Scott Jercich
Project Manager
CRR Implementation
California ISO

Subject: Comments on Assumptions/Methodology for CRR Study 2

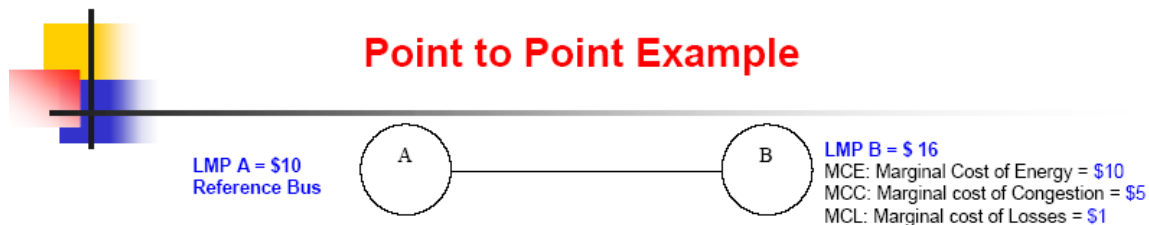
2) The importance of loop flows is seen in the comment on page 3 of LMP Study 3 regarding the April 9, 2003 - AC OPF simulation by CAISO: "Capacity on COI was almost fully scheduled in forward markets, and adding loop flow may place the total flow over the limit in Hours 10 to 13." Again on the May 28 event: "Congestion on COI due to high loop flow."

When Schedule cuts are required for loop flow, in current operational practice, CAISO and BPA determine the amount of required curtailments. Hence if an entity suffers a 100 MW curtailment in COI schedule, it has to make up the 100 MW by other generation (or drop load). Holding a 100 MW CRR for COI is thus not sufficient one would believe. Please comment.
